Meeting: Planning and Development Agenda Item:

Application No: 20/00672/FP

Location: Garages And Forecourt Area To Rear Of 13-19 The Chace

Proposal: Erection of 3no. three bed dwellings, parking and amenity space following

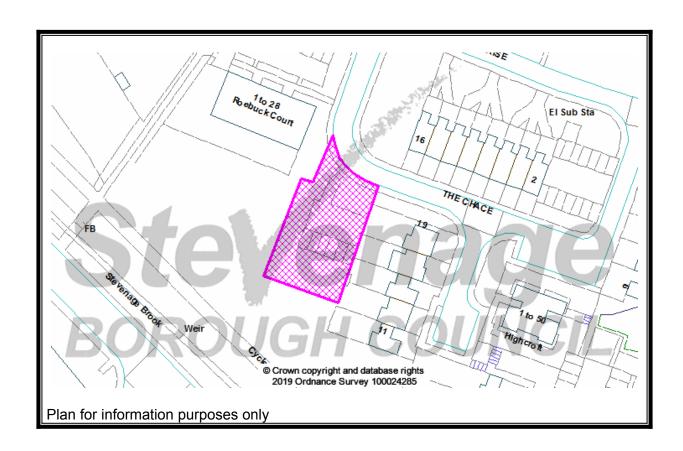
The proposed plans for three consecutive fully ramped crossovers represent an accessibility issue in terms of the Highway Authorities' responsibility to provide a safe and suitable footway network for pedestrians of all ages and abilities and represents a safety issue in the event that the footway crossovers are subject to wet or icy conditions. At the entrances to the driveways a flat area with a width of 900mm carried through at footway level should be provided to enable pedestrians and wheelchair users to avoid the ramps to dropped kerbs. The proposed footway crossovers are not in-line with section 1.14.1 Footway and Verge Crossover of the Roads in Hertfordshire: Highway Design Guide.

The Highway Authority are satisfied with the vehicle crossover detail shown on Drawing No. 3055.CHAC.106 as this includes a flat area with a width of 900mm carried through at footway level for all three proposed footway crossovers.

5.1.5 Amended plans were submitted on the 16 January 2021 to address this issue. The Highway Authority was re-consulted and responded on 18 January 2021 with the following comments:
